**ZONING BOARD OF APPEALS AGENDA**  
**July 17, 2013**  
**7:00 PM**  
**CITY HALL**

**CITY OF PEACHTREE CORNERS  
COMMUNITY DEVELOPMENT DEPARTMENT  
VARIANCE ANALYSIS**

ZBA HEARING DATE: July 17, 2013  
CASE NUMBER(S) : **V2013-004**  
ZONING : C-2 (GENERAL BUSINESS DISTRICT)  
LOCATION : 3200 BLOCK OF PEACHTREE CORNERS CIRCLE  
MAP NUMBER : R6276 019 & R6276 073  
PROPOSED DEVELOPMENT : CONVENIENCE STORE WITH FUEL PUMPS  
VARIANCE(S) REQUESTED : **a) INCREASE CANOPY SIGN SIZE  
FROM 8 SQUARE FEET TO 20 SQUARE FEET

RE: QuikTrip # 735 – Variance Request

Flat Entry /  
Custom Chamfered Building

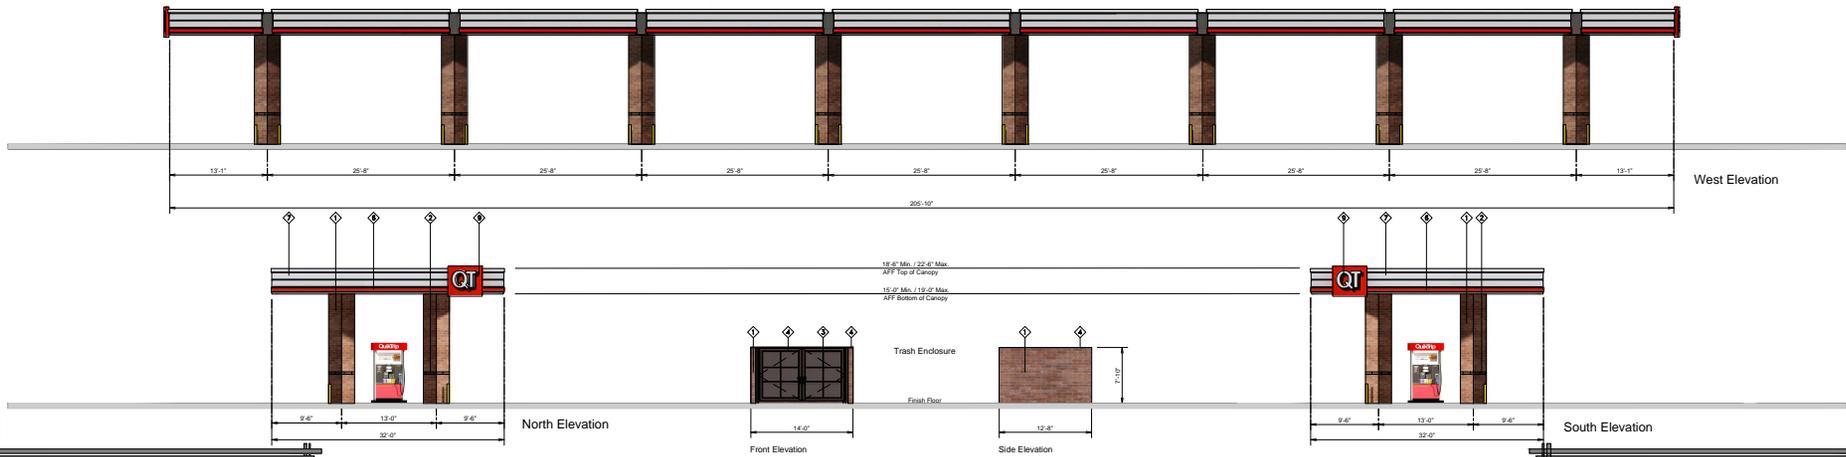
QuikTrip also seeks to eliminate the overlay district requirement for incorporation of 1-foot deep cornices and 1-foot height contrasting base along the entire front façade and the sides of the building for at least 10 feet. The Burger King restaurant located directly south of the subject property and within the Peachtree Corners Overlay District, was constructed with cornices around the entirety of the parapet roof and also a contrasting stone base. The elevations submitted by the applicant shows that the front of the proposed convenience store building partially complies with the requirements of the overlay district, as cornices are provided on top of the flat roof and a base line of bricks is provided underneath the glass windows along the front façade. Not fully complying with the architectural requirements of the overlay district could establish a negative precedent; *however, the proposed building elevations appear to meet the intent of the regulations and, in this case, a strict adherence to the standards may result in a building that looks 'overly busy' and, therefore, less attractive.*

- QuikTrip request a variance from the following architectural requirements, the building design shall include minimum 1' deep cornices, extending along the entire front and the sides of the building at least 10'(Section 1315.2.5.5B.5)

- QuikTrip request a variance from the following architectural requirements, the building design shall include minimum 1' high contrasting base, extending along the entire front and the sides of the building at least 10'(Section 1315.2.5.5B.6)

4. Building elevations shall be substantially similar to QuikTrip elevations drawings dated 5/29/13.
5. Lighting shall be contained in cut-off type luminaries and shall be directed in toward the property so as not to reflect into adjacent properties. Provide photometric plan at time of submittal of land disturbance permit to show compliance with this condition.

Vertical 8  
Gas Canopy Elevations

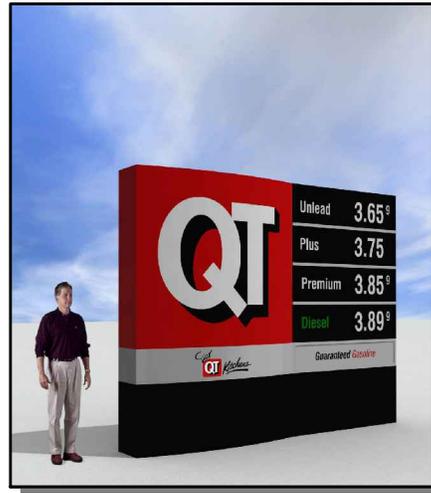
The applicant seeks to install a 20 square-foot sign on the north and south ends of the canopy. The City of Peachtree Corners Sign Ordinance allows convenience stores with fuel pumps to have two signs per canopy face with each sign limited to 8 square feet in size. Under the existing Sign Ordinance, a four-sided canopy is permitted a total of 8 canopy signs with an aggregate total of 64 square feet of signage. Although the applicant's request would allow for individually larger signs, the request would limit the site to only two canopy signs and an aggregate square footage of 40 square feet. The overall reduction in the number and aggregate square footage of canopy signage would contribute to the applicant's intent of providing an aesthetically pleasing and streamlined design. *Therefore, if this variance is granted, individual signs would be larger, however, the number of signs and overall square footage of signs would be reduced.*

- QuikTrip requests a variance to increase the Canopy sign from 8 Square feet to 20 Square feet. The ordinance allows for 2 canopy signs per canopy facing at 8 Square Feet each, QuikTrip is only requesting 2 canopy signs at 20 Square feet each.(Section 18.A.1)

1. The subject property shall be limited to two canopy signs with each sign not to exceed 20 square feet.
2. Interior driveways immediately surrounding the fuel pump canopy shall be no greater than 47 feet in width.
3. Interior driveways providing primary access to loading or unloading zones shall be no greater than 17.5 feet in width per travel lane.

SHEET TITLE:  
LANDSCAPE PLAN

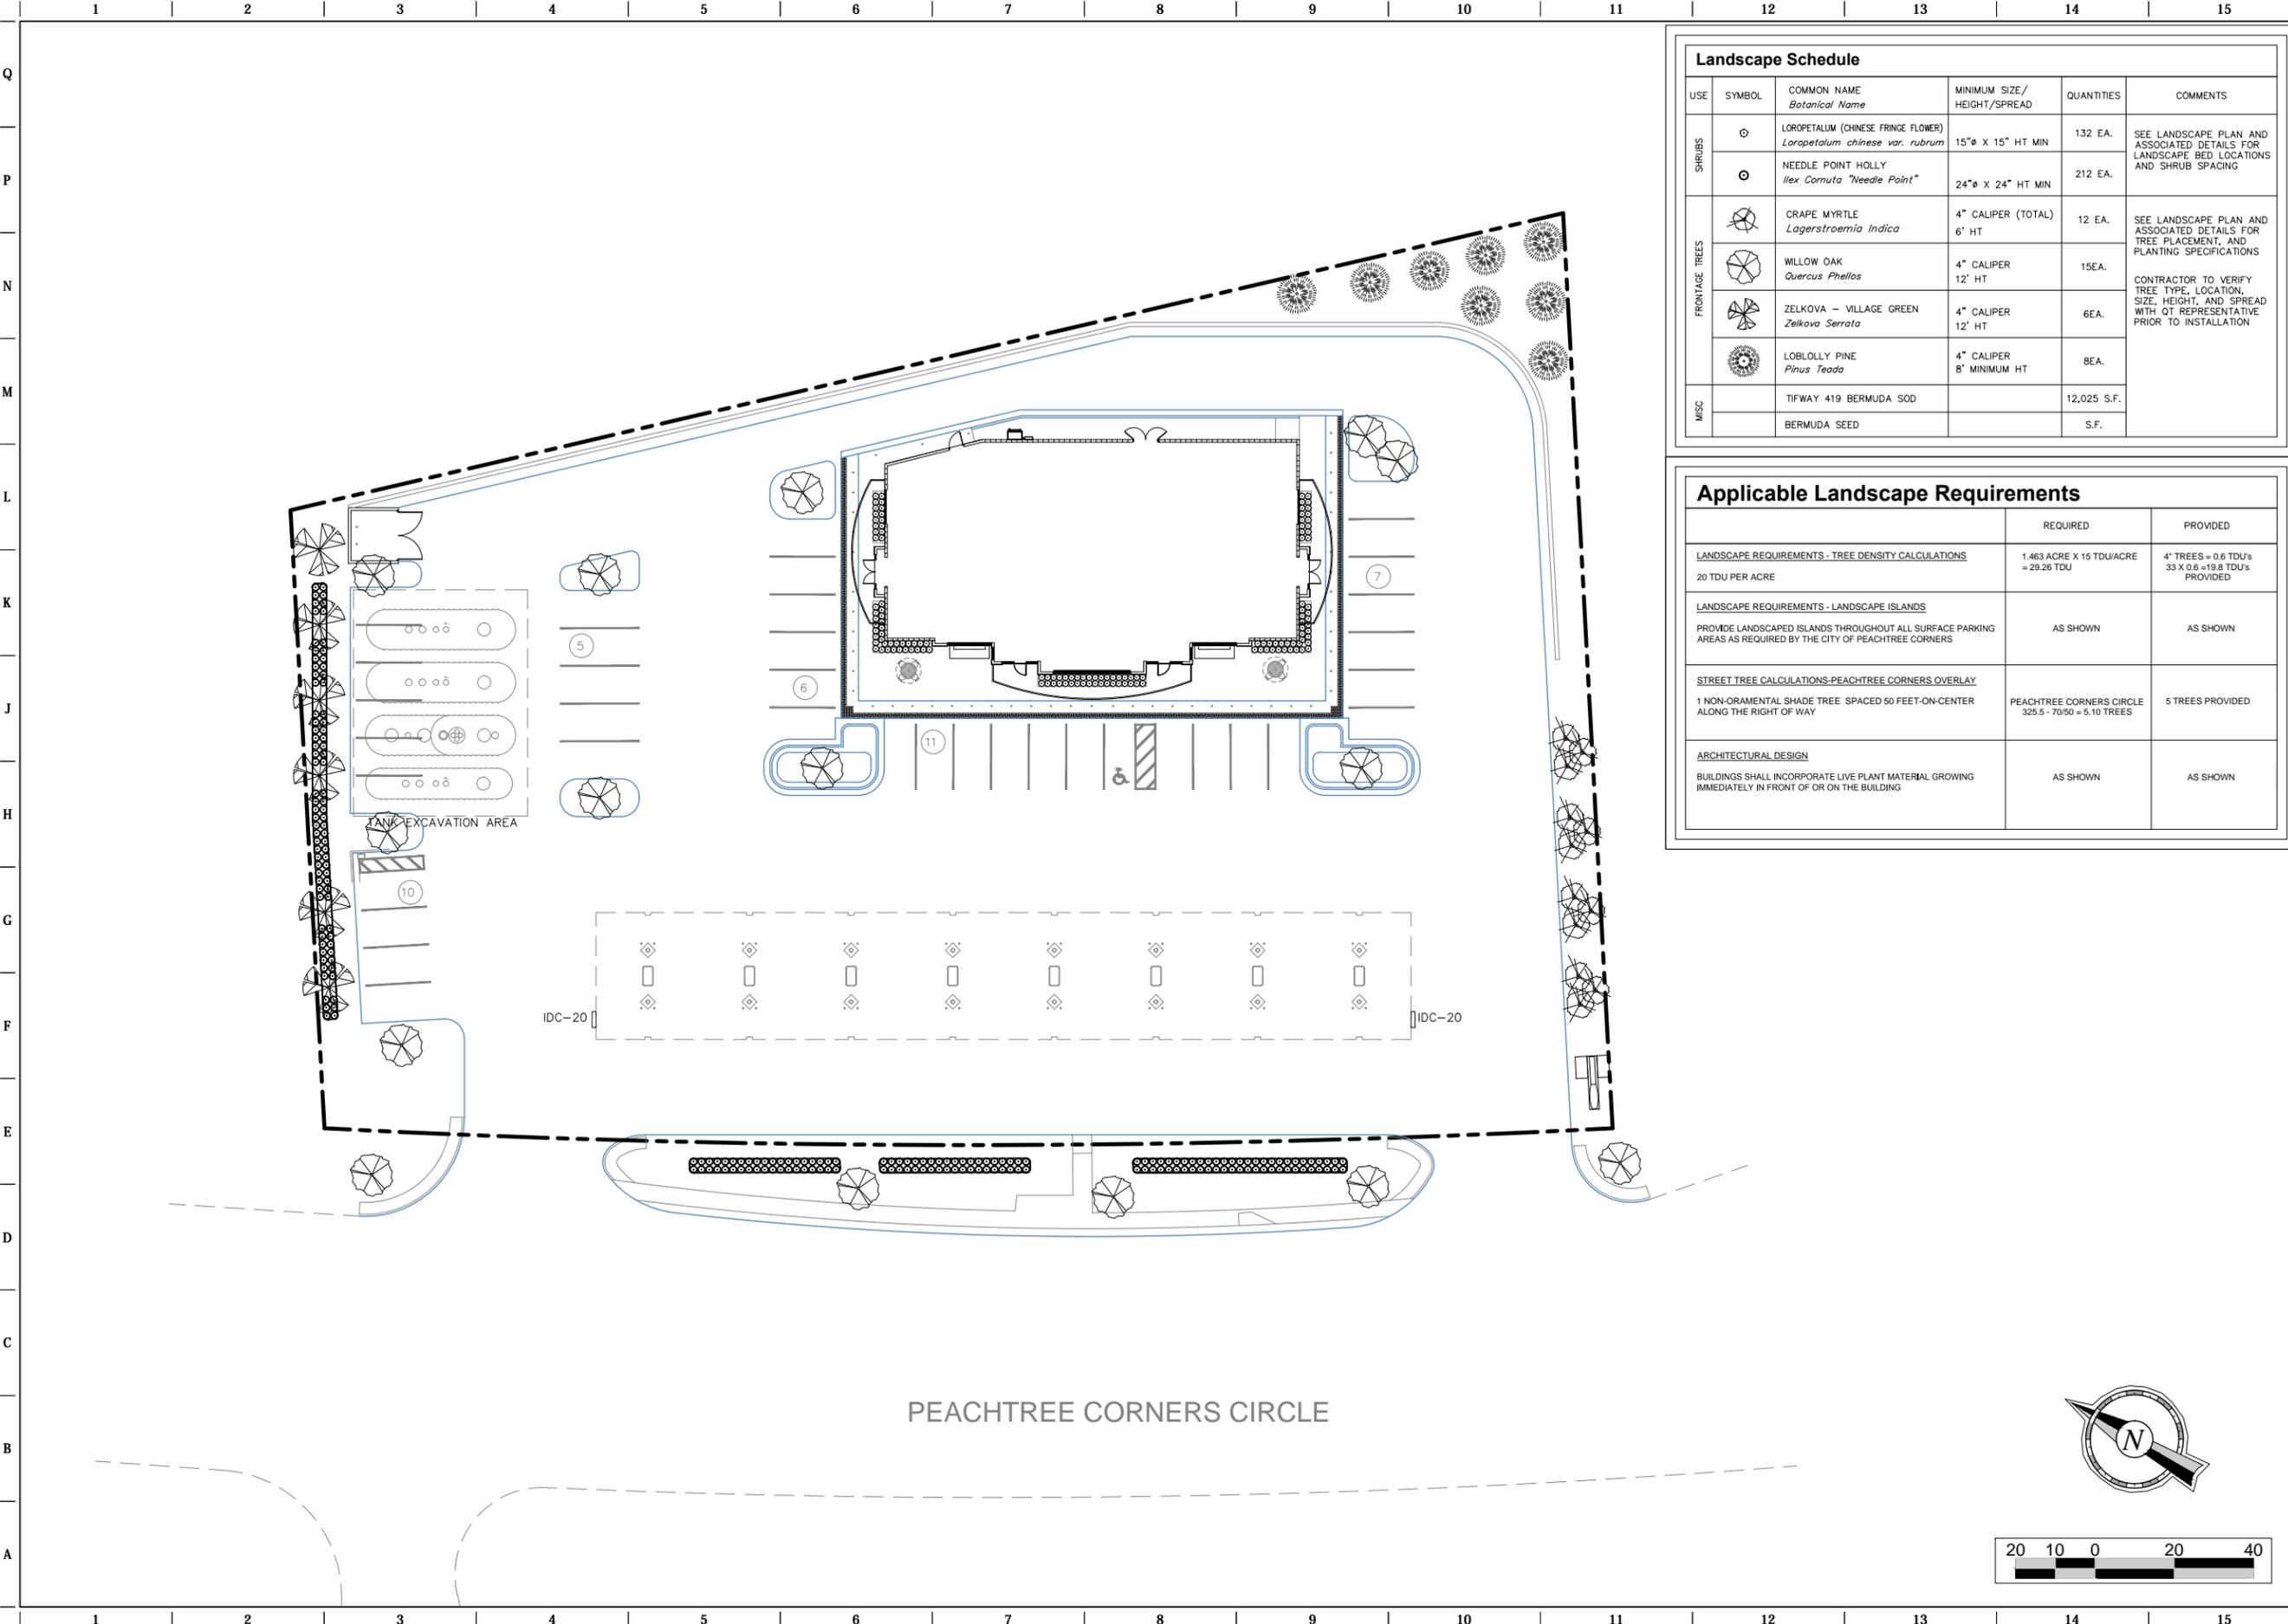
The subject property lies within the Activity Center/Corridor Overlay District and is required to provide 20 Tree Density Units per acre; however, the applicant seeks to reduce the tree density to 13.5 units per acre. Staff has compared the as-built survey to the proposed site plan and has determined that a significant portion of existing vegetation of evergreens/pines located along the rear property line of both parcels, which could have been counted towards compliance with the tree density requirement, would be removed and replaced by a minimal landscape plan. The proposed landscape plan would incorporate a single row of trees along the sides and southeast corner of the property and within the landscape island located in the right-of-way of Peachtree Corners Circle. Although the purchase of the adjacent coin laundry site would expand the Quiktrip property by slightly more than a third of an acre and the proposed redesign of the canopy area from a double row of fuel pumps to a single row would provide additional space to orient the larger convenience store footprint closer to the road, the applicant has elected to locate the building towards the rear property line and to provide circular vehicle access by constructing a driveway behind the convenience store, further reducing vegetated areas and increasing impervious surface. By redesigning the layout of the property and eliminating extra parking spaces (a minimum of 12 spaces are required and 39 are provided), the proposed convenience store could be relocated towards the northern property line and closer to the road to preserve existing vegetation and to comply with the landscaping requirements of the overlay district. Alternatively, the 60 ft. distance from the building to the gas pumps could be reduced to accommodate the additional landscaping along the front.

QuikTrip seeks to reduce the 10-foot landscape strip along Peachtree Corners Circle as required by the Activity Center/Corridor Overlay District to 1-foot. The proposed site plan shows that the distance from the right-of-way to the central point of the gas pump base is 40 feet. With a 10-foot landscape strip incorporated along the road frontage there would be approximately 20 feet of clearance from the landscape strip to the nearest canopy support column. Per the City's Zoning Ordinance interior driveways providing a width of 20 to 22 feet could provide safe travel for two-way traffic. Providing a full 10-foot landscape strip could also provide additional greenspace for the site to comply with the tree density requirement of the overlay district. Furthermore, addition of a 10-foot landscape strip could contribute to the safe ingress/egress of vehicles for the site by providing additional length for stacking of vehicles exiting the property and could assist in influencing vehicles entering the site to utilize interior driveways to access fuel pumps and limit the possibility of vehicles accessing the fueling area by entering diagonally from Peachtree Corners Circle. *While the tree density and landscape strip variances would allow for design convenience, adjustments could be made to the site plan to accommodate the required trees and green space.*

- QuikTrip request a variance to reduce the required tree density units from 20 units per acre to 13.5 units per acre. This variance is being requested because of the topography and limited depth of the lot. (Section 1315.2.2A)

- QuikTrip request a variance to reduce the required front landscape strip from 10' to 1'. This variance is being requested due to the unique shape of the property and in an attempt to allow traffic to move safely around the site. The existing QuikTrip has a front landscape strip of 2', which can be viewed on the submitted survey. (Section 1315.2.2C)

7. Plans shall comply with the Buffer, Landscape and Tree Ordinance requirement of 16 units/ acre and Overlay requirement of 1 tree/ 50 feet of frontage.

8. Shrubs and ornamental ground covers shall be provided along front and side landscape strips (3' island minimum) and in landscape islands (instead of grass). The side shrub planting should extend 80' minimum from frontage.
